Notice of Intent

TOP SPOT 12_13

Type of Action: APD Change

Procedure Description: OXY USA Inc kindly requests the to update the Deep Intermediate Cement Job to align with the agreed upon R111-P updates presented from the JITC. Updated cementing tables are attached.

Figure C] 4 - String - Un Cemented Annulus

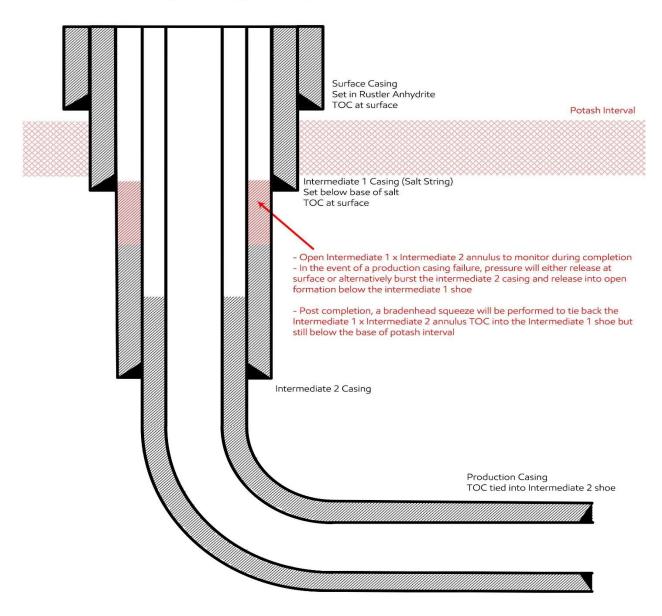
Oxy requests to update the Deep Intermediate Cement Job to align with the agreed upon R111-P updates presented from the JITC. I've included 4 tables below due to the different target benches:

4-String Design - Open Int 1 x Int 2 Annulus

ALL PREVIOUS COAS STILL APPLY. CEMENT DESIGN UPDATE AS PER KPLA BEST PRACTICES (4-STRING INT1 X INT2 OPEN ANNULUS)

Operator has proposed to pump down 7-5/8" X 9-5/8" annulus POST-FRAC.

Operator must top out cement after the bradenhead squeeze and verify cement to surface. Operator can also check TOC with Echo-meter. CBL must be run from TD of the 7-5/8" casing to surface if confidence is lacking on the quality of the bradenhead squeeze cement job. Submit results to BLM.
